Burk's Falls West Solar Project

Modification Document – Proposed Relocation of Stormwater Diversion Channel

H353720-00000-121-066-0001

Figure 1-1
 Northland Power Inc.
**Burk's Falls West Solar Project
 Waterbody Amendment**
HATCH

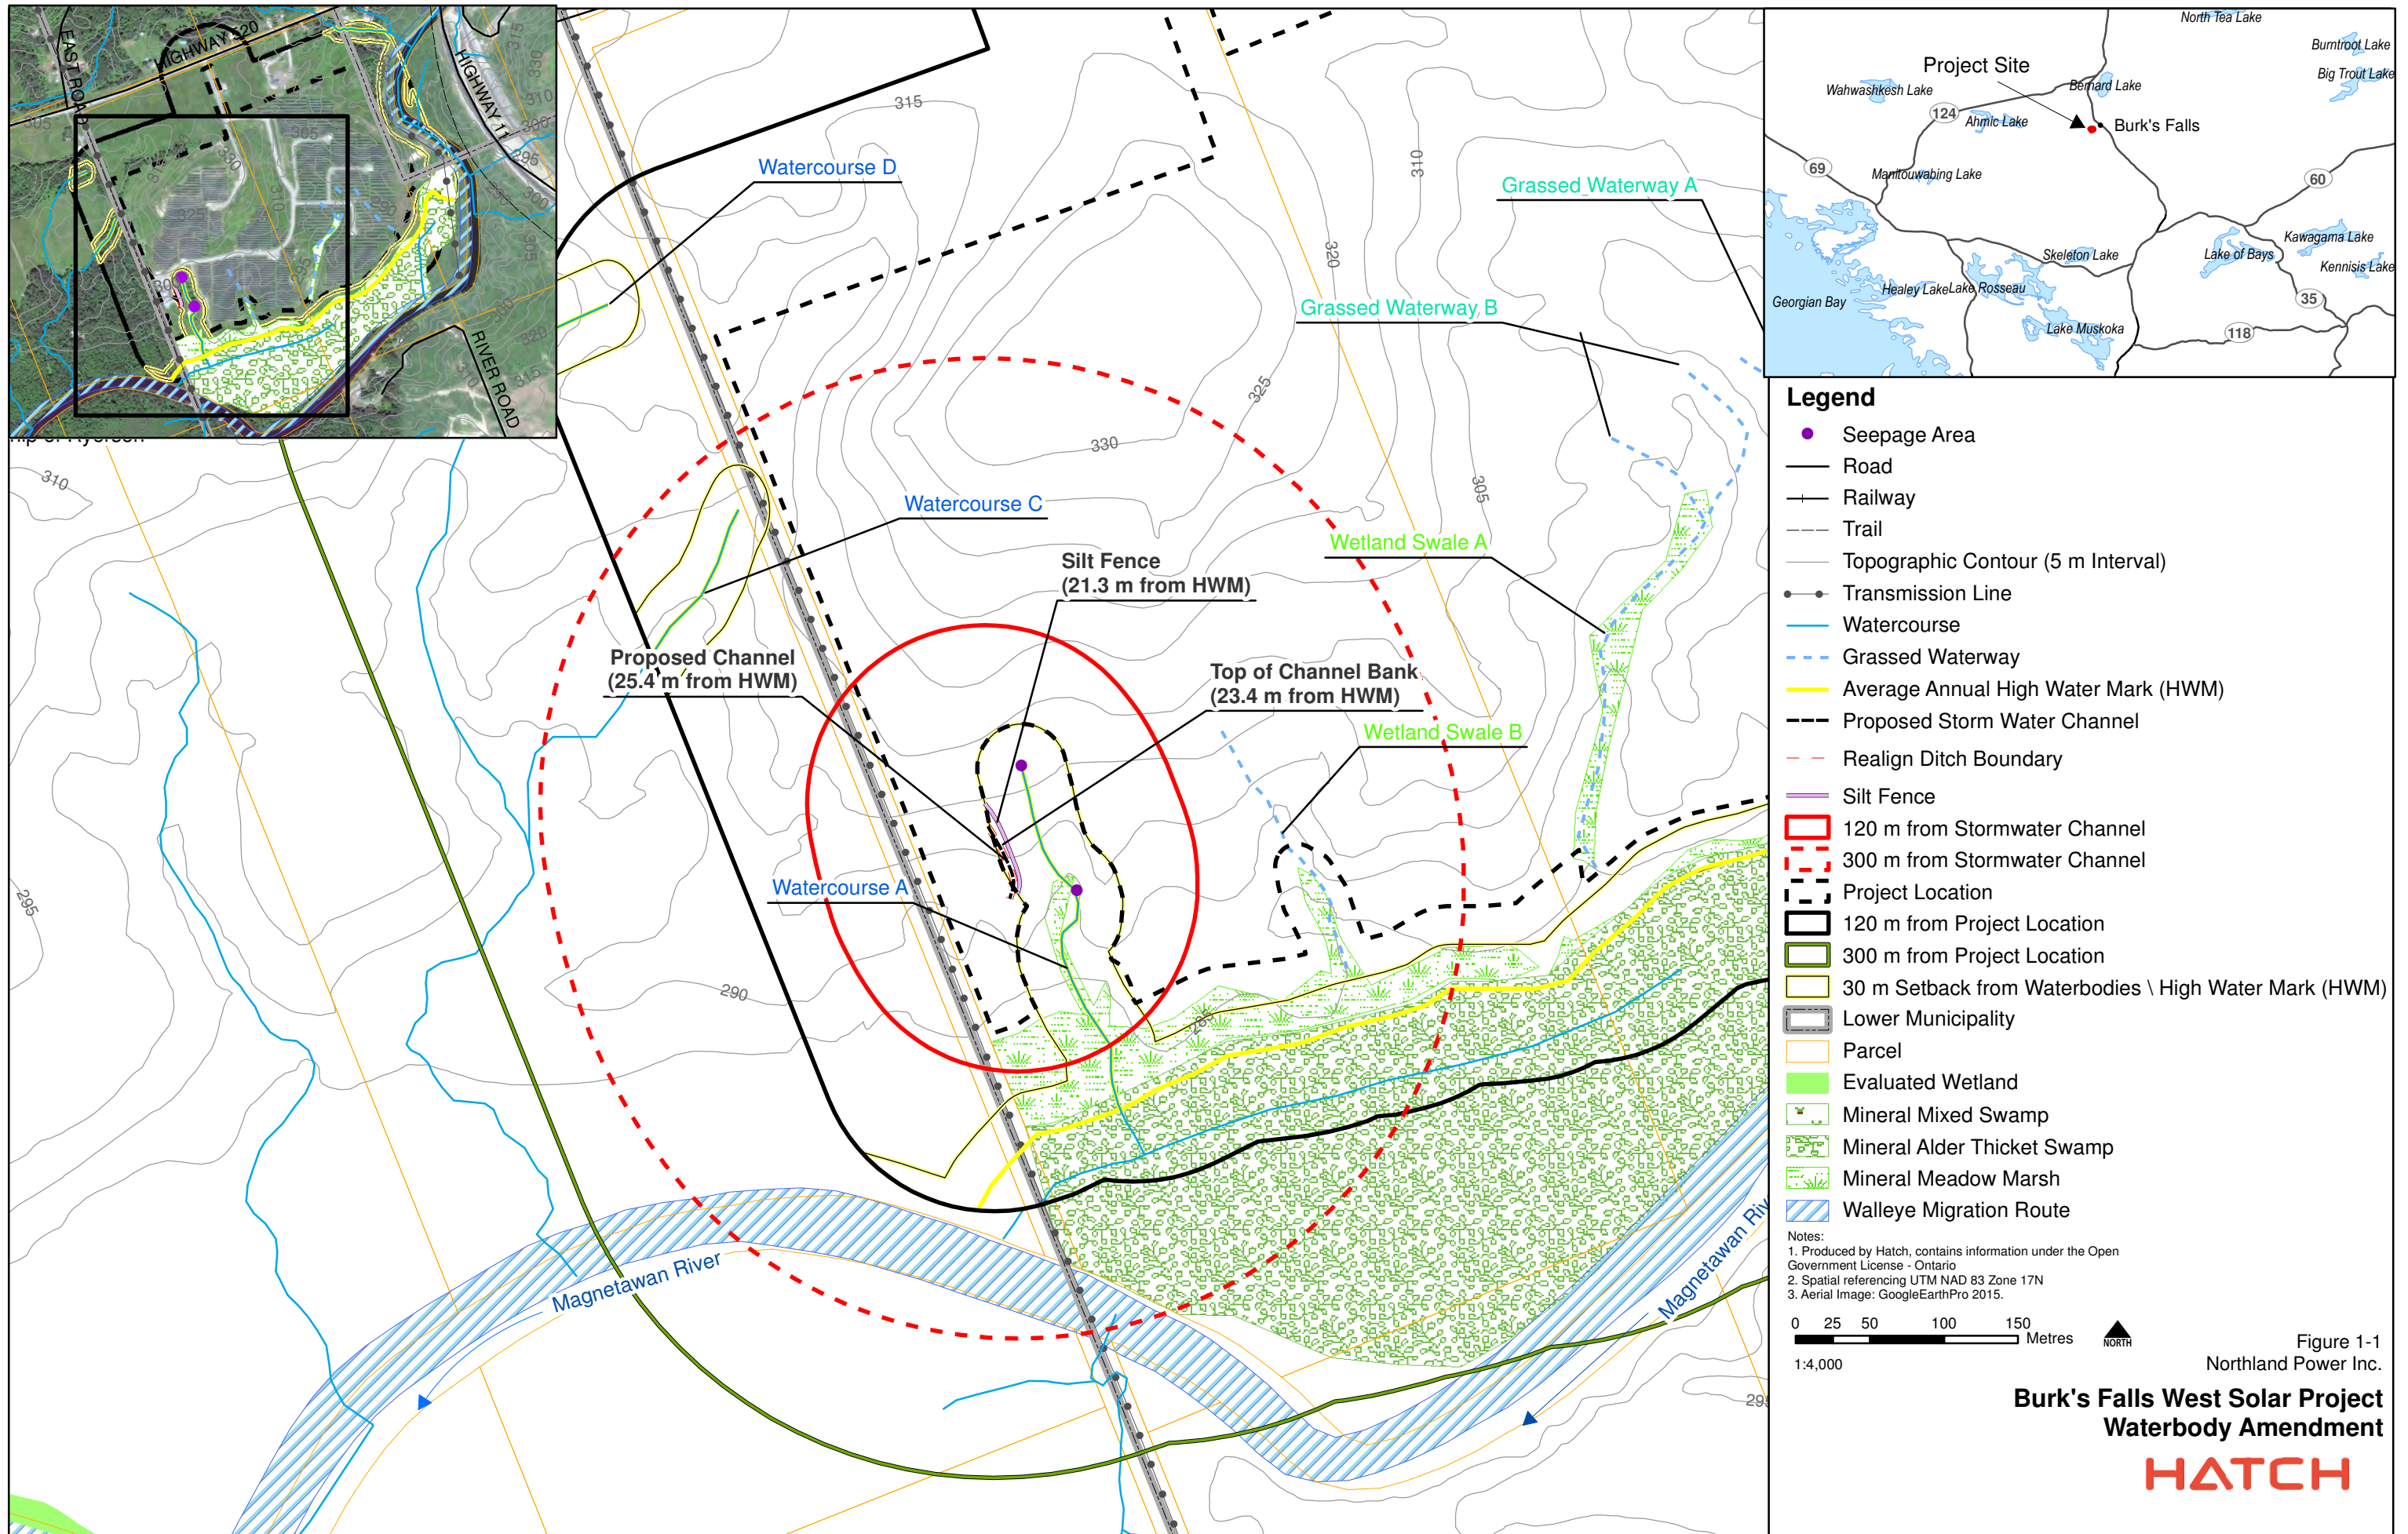
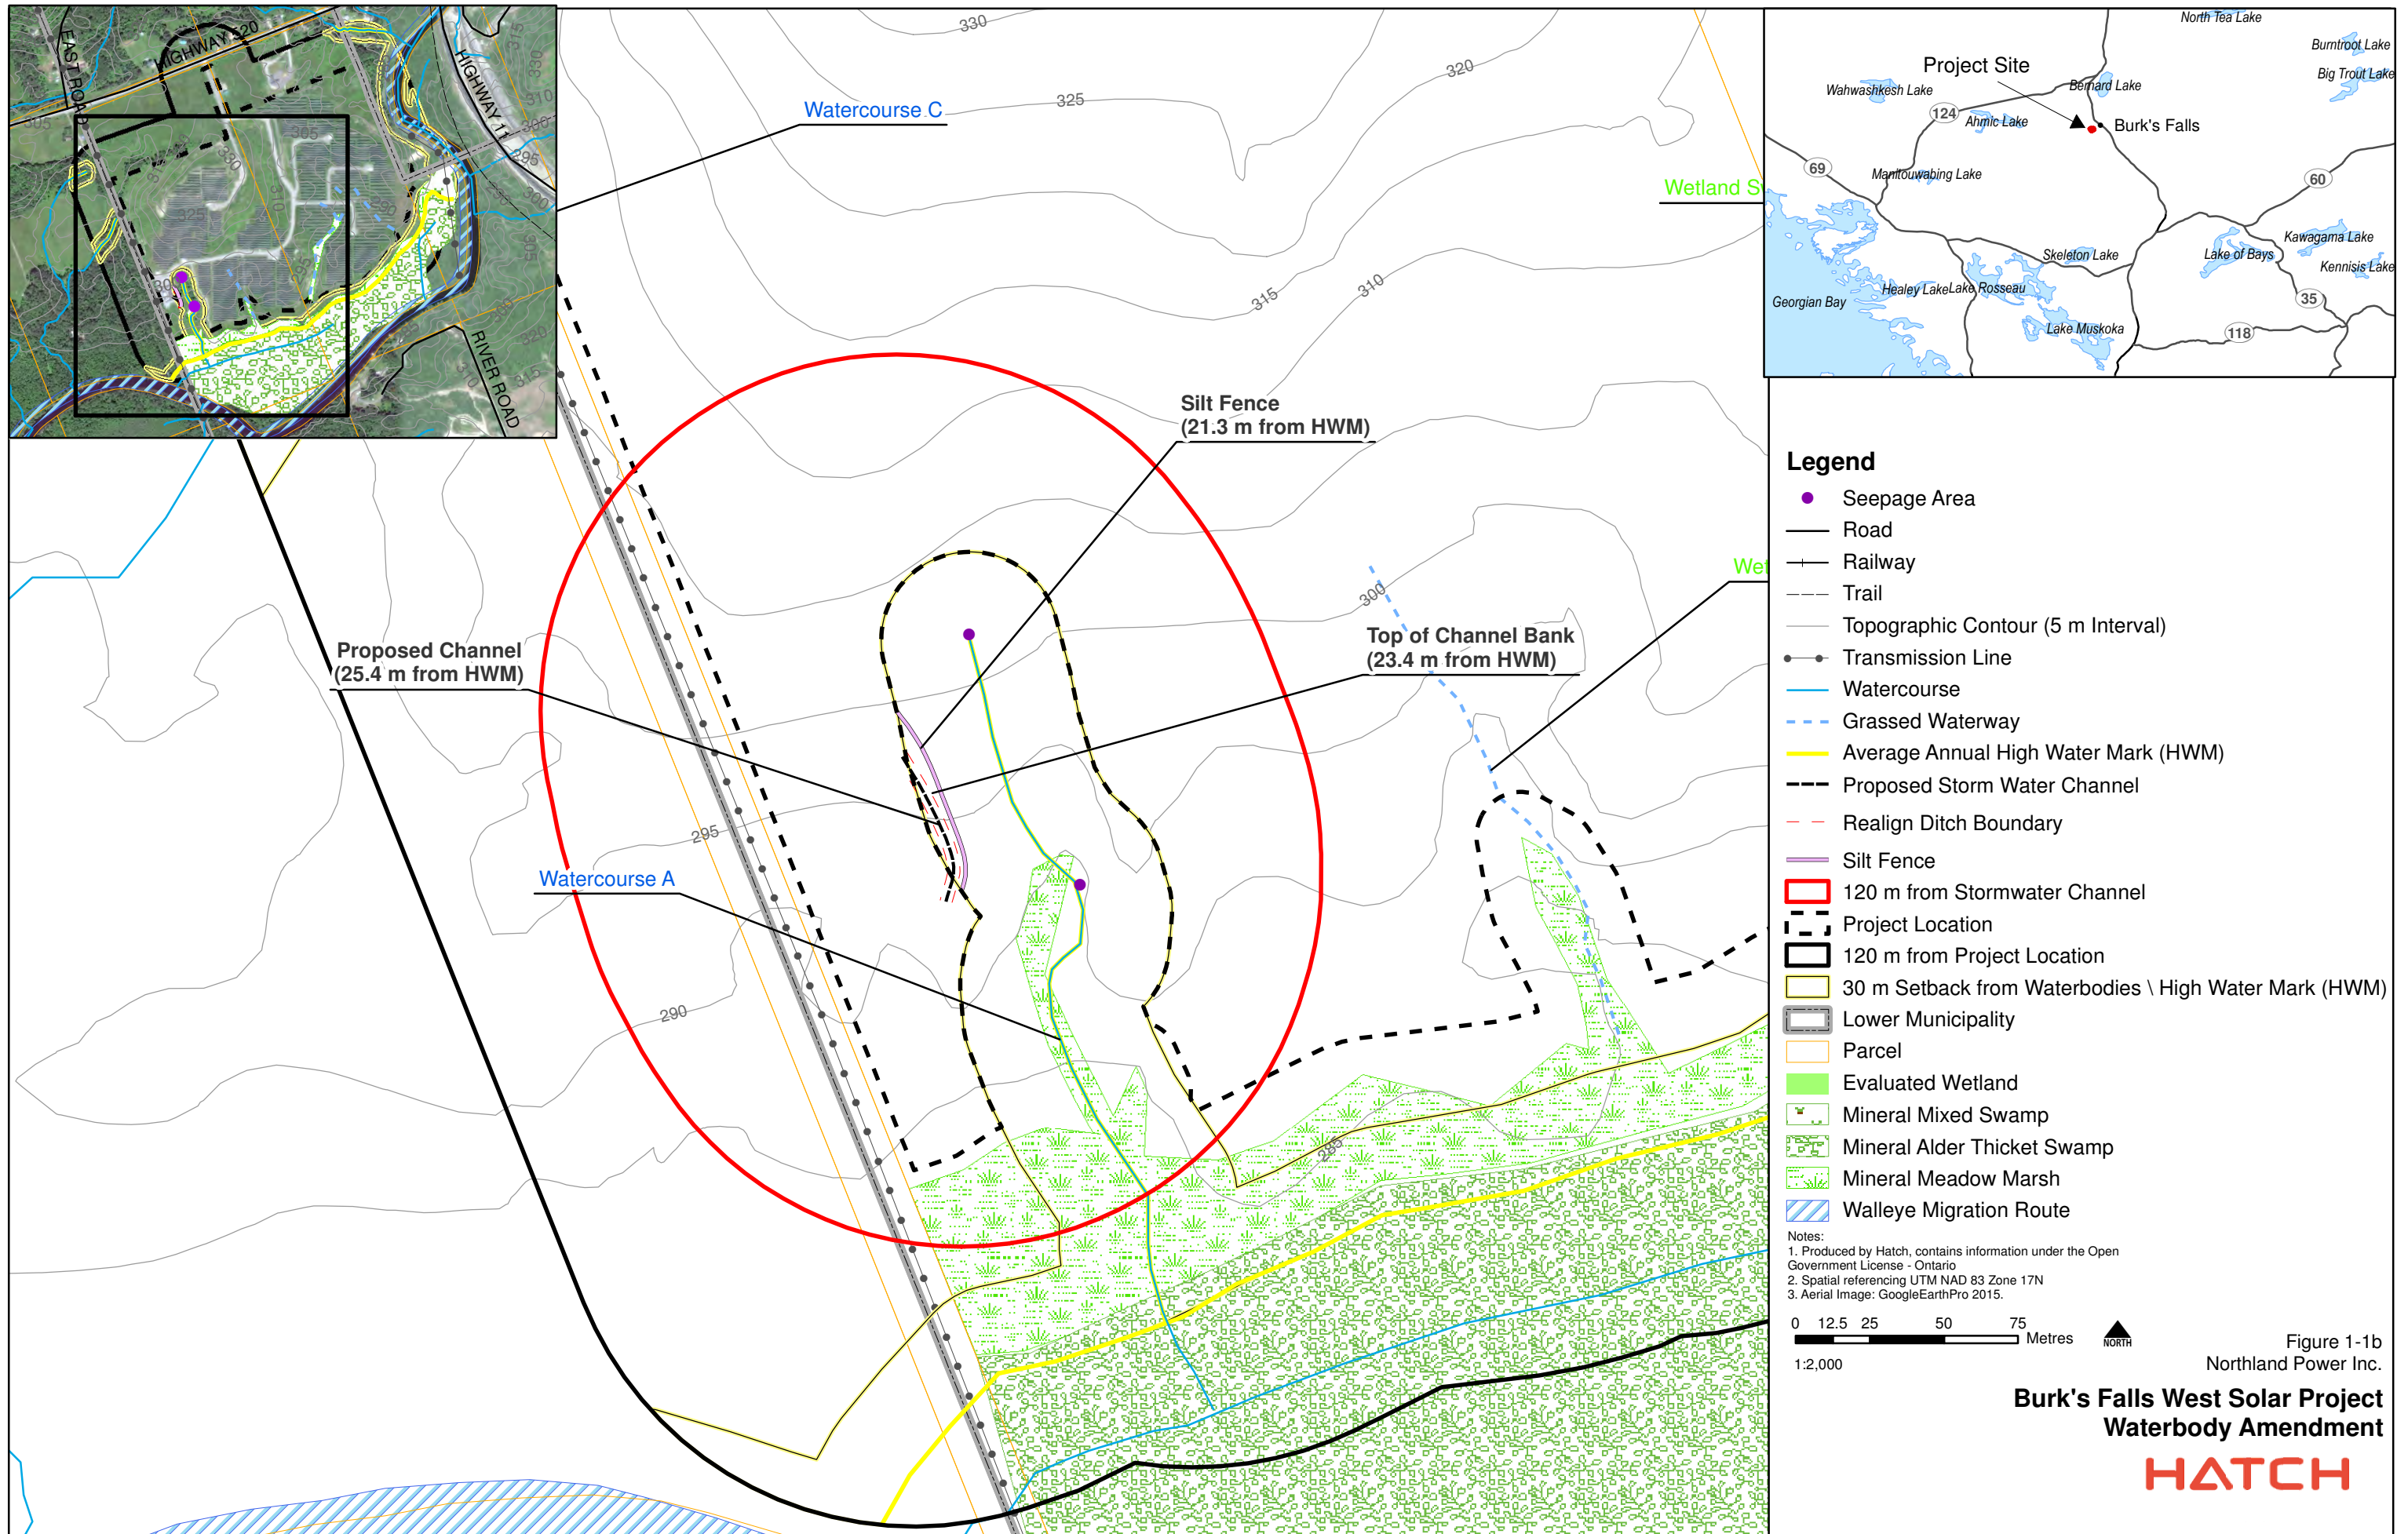
This Environmental Impact Study has been prepared to address these requirements for the construction of the diversion channel to encroach on Watercourse A 30 m setback reducing the setback to 23.4 m. Table 2 outlines proposed changes within Hatch’s 2011 Environmental Impact Study in order to facilitate this change.

Section	Original Text	Amended Text
		encroachment of a diversion channel to within 23.4 m of Watercourse A (Figure 1-1).
4.1.1.3	No vegetation removal will be required within the 30-m buffer adjacent to any of the waterbodies.	No vegetation removal will be required within the 30-m buffer adjacent to any of the waterbodies. With the exception of the grading required for creation of the diversion channel located west of Watercourse A. (Figure 1-1).

Figure 1-1
 Northland Power Inc.
Burk's Falls West Solar Project
Proposed Stormwater
Channel Realignment
HATCH

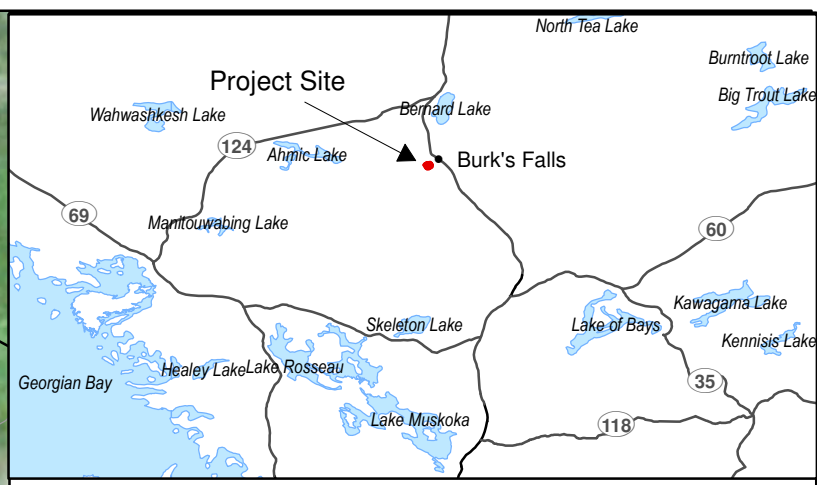
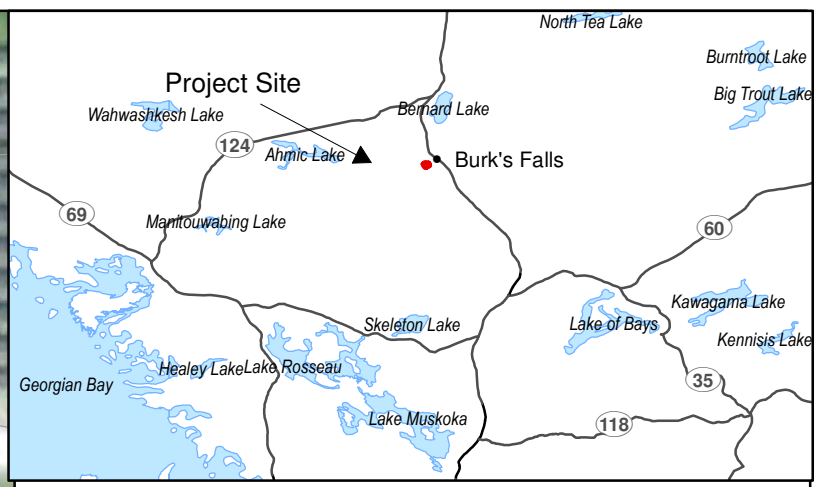
substation to prevent undercutting. The relocated stormwater diversion channel will be within the 30 m set-back established from a watercourse identified during the 2011 Site Investigations (Figure 1-1). The encroachment into the setback area is proposed to be approximately 6.6 m, thereby maintaining a 23.4 m setback from the watercourse. To complete the channel, approximately 204 m² of existing soils would be shaped, stabilized with rip/rap stone and revegetated; the discharge is not within a watercourse and as such, sediment or hydrology concerns are mitigated during storm events.
